January 14, 2015

In the Matter of)
)
)
DTE ELECTRIC CO.) Docket No. 52-033
)
)
(Fermi Nuclear Power Plant, Unit 3))

NRC STAFF RESPONSES TO COMMISSION PRE-HEARING QUESTIONS

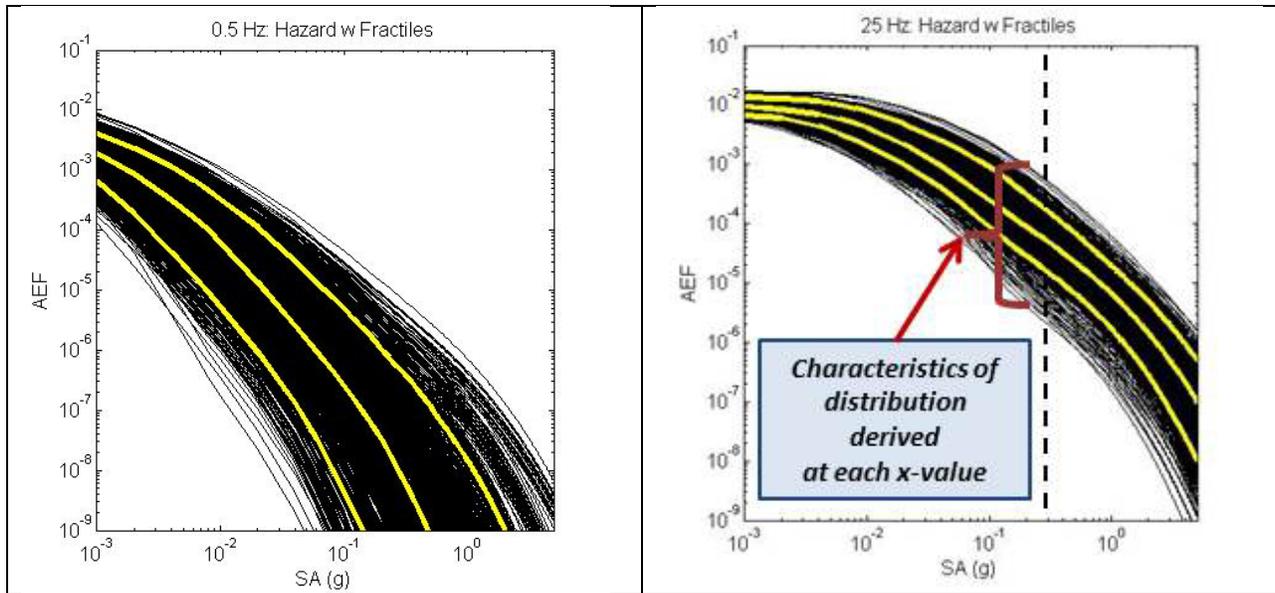
15. Subsection 2.5.2.4 of the FSAR describes the applicant's Probabilistic Seismic Hazard Analysis (PSHA) calculations for the Fermi Unit 3 site, including the generation of seismic hazard curves. These hazard curves show the probability of exceeding a certain ground motion level. For any given vibration frequency the hazard is given by a family of curves that account for uncertainty in the calculations. A behavior that has been observed to be common in these hazard curves is that this uncertainty varies significantly per vibration frequency. Explain how the potential implications of this observation were accounted for in determining whether the Fermi Unit 3 site meets the standard seismic design requirements in the DCD.

Different elements of the uncertainty can have differing impacts on the derived seismic hazard curves for each ground motion vibration (spectral) frequency. For instance, the uncertainty in the geometries or boundaries of seismic source zones may affect the hazard estimates similarly for all ground vibration frequencies. However, the uncertainty in the maximum magnitude applicable for a seismic source zone and the uncertainty in applicable ground motion models lead to a larger uncertainty in hazard for lower spectral frequencies (< 2.5 Hz) than for higher spectral frequencies (10 Hz or greater).

Figure Q-14a (below) illustrates this effect by utilizing a single representation of a seismic source zone impacting the Fermi 3 site. Black lines are individual seismic hazard curves calculated using alternative model parameters. Yellow lines indicate 5%, 50% (median), and 95% percentiles calculated from the distribution of the black curves at each x-value. Even though this is a result from a simplified model, the suite of seismic hazard curves shown for 0.5 Hz and 25 Hz frequencies demonstrate variable ranges in hazard (the y-axis) due to frequency-specific and variable impacts of different elements of the uncertainty model. Specifically, the hazard curves shown below in Figure Q-14a are for the base or very hard rock conditions at the Fermi 3 site. For this geologic setting, the hazard curves for the 25 Hz spectral accelerations, shown on the right, are higher, with smaller ranges of uncertainty for specific values of spectral acceleration, than the hazard curves for the 0.5 Hz spectral accelerations, shown on the left, which are lower and have larger ranges of uncertainty. This is primarily due to the larger number of postulated earthquakes over a wider range of magnitudes and distances in the region surrounding Fermi 3 being able to produce relatively high 25 Hz spectral accelerations. In contrast, not as many postulated regional earthquake scenarios for Fermi 3 are able to produce large 0.5 Hz spectral accelerations, which results in lower hazard curves with larger ranges of uncertainty for this lower spectral frequency.

Staff Response to Questions 14 and 15: The following discussion describes how uncertainty is factored into the development of the seismic hazard characterization for a site by providing a description of (1) the seismic siting regulations, (2) the development of seismic ground motion curves for a site, (3) seismic design requirements, (4) the probabilistic seismic hazard approach, and (5) the use of mean hazard curves.

For all ground motion frequencies, the mean hazard is directly derived from the uncertainty represented in the complete suite of hazard curves (such as those shown in the figure above with black lines). Thus, for each ground motion frequency, the mean hazard incorporates the uncertainty included in the seismic source characterization and ground models and the use of the target MAFE is consistent with achieving the performance goals and seismic margins inherent in RG 1.208.

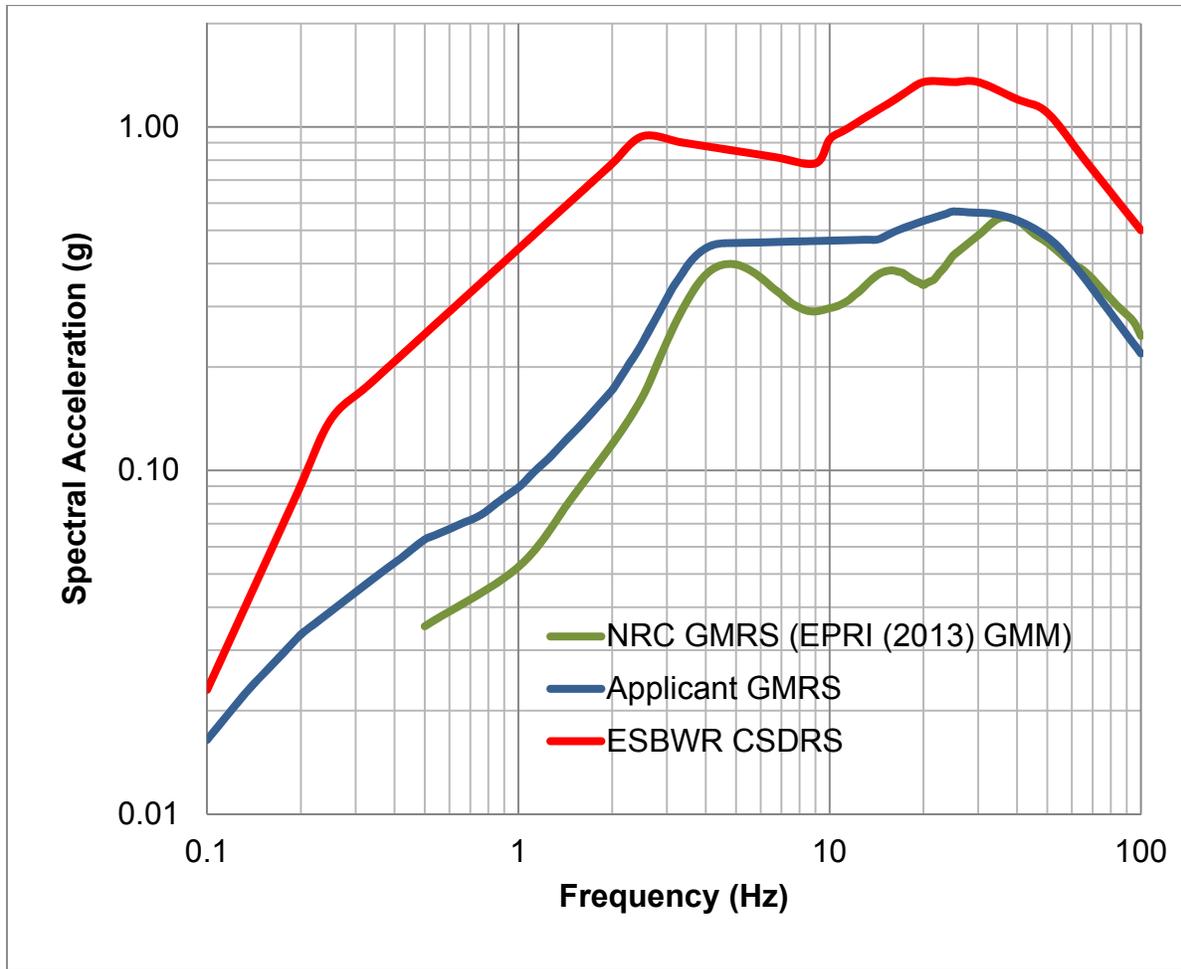
- 29. To address Near Term Task Force (NTTF) Recommendation 2.1, the Staff requested the applicant to evaluate the potential impacts of the NUREG-2115 seismic source model on the Fermi Unit 3 seismic hazard and to modify the site-specific ground motion response spectra (GMRS) and foundation input response spectra (FIRS) as necessary. In response, the applicant updated its PSHA and respective GMRS and FIRS reflecting the use of the NUREG-2115 seismic source model. In this update, the applicant used the Electric Power Research Institute (EPRI) 2004/2006 ground motion model (GMM). In 2013, EPRI published an update to the 2004/2006 ground motion model called the EPRI 2013 GMM. The EPRI 2013 GMM is currently being used by licensees in their assessments related to NTTF Recommendation 2.1. Describe how the Staff verified the adequacy of the use of the 2004/2006 EPRI GMM instead of the 2013 EPRI GMM to address NTTF Recommendation 2.1 for Fermi Unit 3.**

Staff Response: In response to RAI 01.05-1, the applicant provided an evaluation of the potential impacts of the NUREG-2115 seismic source model on the Fermi 3 seismic hazard, on March 15, 2013. The response included an updated Probabilistic Seismic Hazards Analysis (PSHA) with a revised Ground Motion Response Spectra (GMRS) and Foundation Input Response Spectra (FIRS). The applicant's revised GMRS and FIRS utilized the new NUREG-2115 seismic source model and the Electric Power Research Institute (EPRI) 2004/2006 ground motion model (GMM). An updated version of the EPRI 2004/2006 GMM (EPRI 2013) was later endorsed by the NRC on August 28, 2013 (ADAMS Accession No. ML13233A102).

Whenever new seismic information, including newer models, becomes available, consistent with RG 1.208, the staff considers whether the applicant's use of an older model remains acceptable. The staff found DTE's use of the EPRI 2004/2006 GMM acceptable based on comparisons of the EPRI 2004/2006 model to more recent models. DTE had previously submitted sensitivity analyses in response to an earlier RAI (RAI 02.05.02-4 issued on November 12, 2009), comparing the EPRI 2004/2006 GMM results to other newer ground motion models available at that time. The applicant concluded, and the staff agrees, that the median ground motions obtained using the newer ground motion prediction equations—specifically Silva et al. (2003), Atkinson and Boore (2011), and Pezeshk et al. (2011)—produce similar or lower ground motion amplitudes compared to the EPRI (2004) GMMs, and are thus in general likely to produce lower hazard levels for a site. Further, the staff considered hazard calculations performed at seven test sites detailed in Chapter 8 of the EPRI (2013) report comparing the updated EPRI (EPRI 2013) GMM results to EPRI 2004/2006 GMM results. One of the seven test sites is the Central Illinois test site, which is the closest test site to the Fermi 3 site. The EPRI (2013) report demonstrates that the updated EPRI (EPRI 2013) GMM produces equivalent or lower seismic hazard results when compared to the EPRI 2004/2006 GMM at all seven test sites. Therefore, the staff concluded that the seismic hazard submitted by DTE using the EPRI 2004/2006 GMM is equivalent or higher (more conservative) than would be calculated from the updated EPRI (EPRI 2013) GMM at the Fermi 3 site.

Subsequent to finalization of its technical input to Section 2.5 of the Fermi SER, the staff conducted additional confirmatory analysis, to directly compare the site-specific seismic hazard results obtained using the EPRI 2004/2006 GMM with those obtained using the updated EPRI (EPRI 2013) GMM. These results confirm that, for the Fermi 3 site, the updated EPRI (EPRI 2013) GMM produces generally lower seismic hazard results than the EPRI 2004/2006 GMM. These confirmatory analysis results are shown in the figure below as the green curve labeled "NRC GMRS". The blue curve labeled "Applicant GMRS" is DTE's hazard results calculated using the EPRI 2004/2006 GMM. These results continue to indicate that DTE's use of the EPRI 2004/2006 GMM is conservative, and therefore acceptable.
